- Subject** ▶ Change of Cord Guard, Handle and Handle Cover
- For Models** ▶ HR4000C, HR4040C
- Country** ▶ All countries
- Description** ▶ Cord Guard, Handle and Handle Cover have been changed as illustrated below for further improvement in durability of Power Supply Cord and Cord Guard.

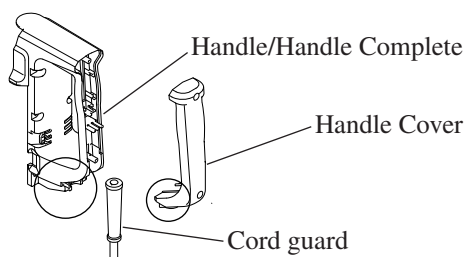
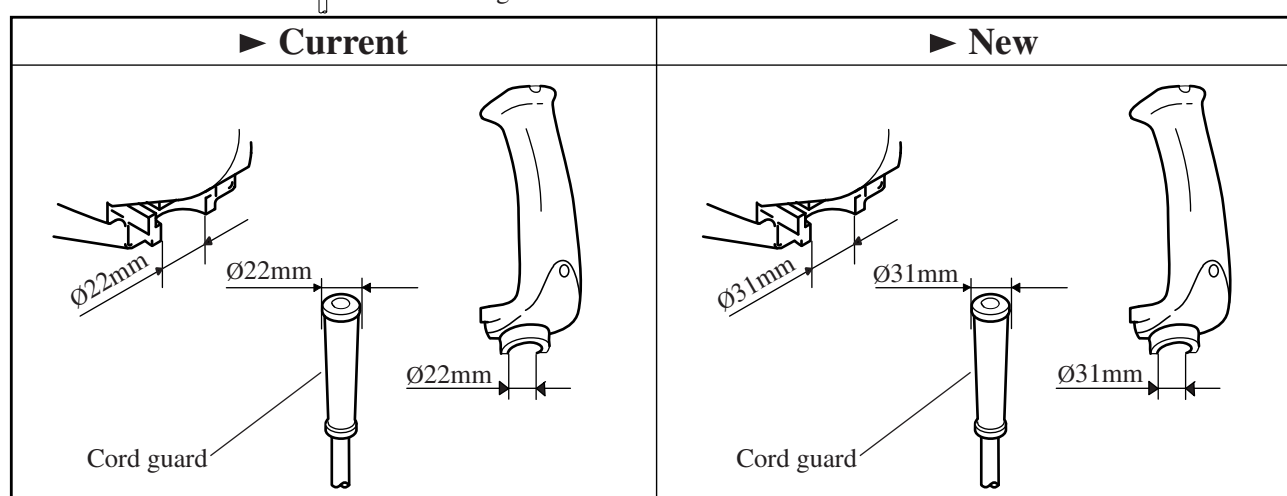
- 1) Cord Guard;  
Replaced by the one with larger neck.
- 2) Handle/Handle Complete and Handle Cover;  
Encircled places has been modified to accept the new Cord Guard.

- The current parts and the new ones are interchangeable as a set of Handle/Handle Complete, Handle Cover and Cord Guard.
- HR4000C : Brazil, Chile, Paraguay, Peru, Uruguay, Switzerland, Syria, North Korea, Philippines, Taiwan, Vietnam  
HR4040C : Guyana, North Korea, Philippines, Thailand, Vietnam
- As the current Cord Guards have been discontinued, use the Cord Guard of part No. **682505-8** when replacing the Cord Guard of the machines manufactured before this modification.
